## 10.0 Steam and Power Conversion System

The information in this section of the reference ABWR DCD, including all subsections, tables and figures, is incorporated by reference with the following departures and supplements.

Figure 10.1-1 Reference Steam and Power Conversion System

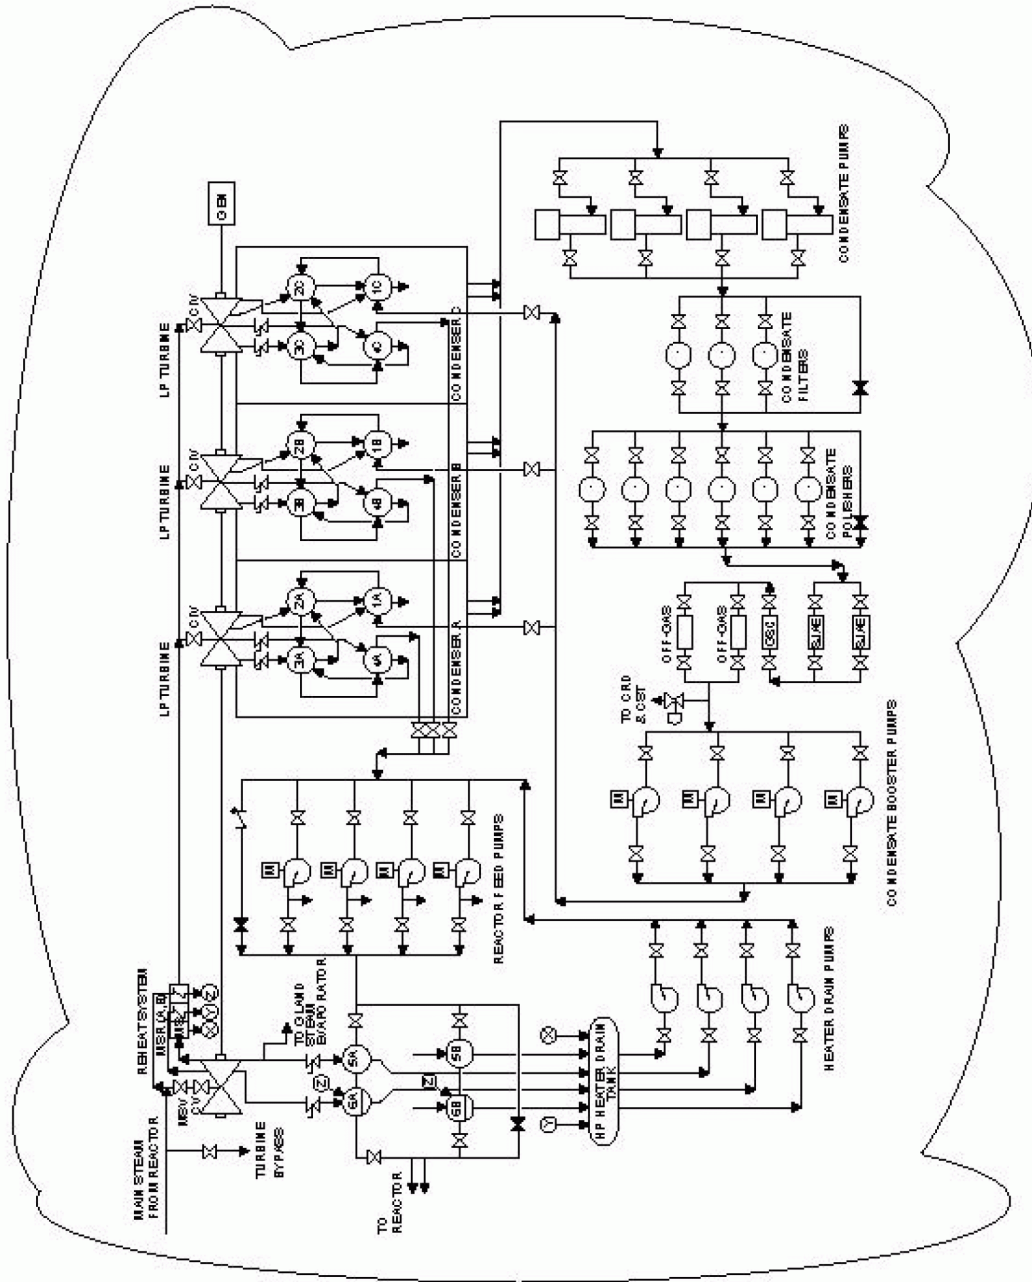
STP DEP 10.1-2 (Figure 10.1-1)

*Major S&PC System design features are summarized in Table 10.1-1. The system main conceptual features are illustrated on Figure 10.1-1, assuming a triple pressure condenser. This type of condenser and other site dependent ABWR plant features and parameters are reported herein based on typical central U.S. site conditions. They are given here to more completely define the ABWR Turbine Island standard design and to be used as references in reviewing future ABWR plant specific licensing submittals, and confirming that such submittals are indeed consistent with the standard design. Nothing in the ABWR Standard Plant design is meant to preclude the use of a once through cooling system and a single pressure condenser nor will such changes affect the Nuclear Island.*
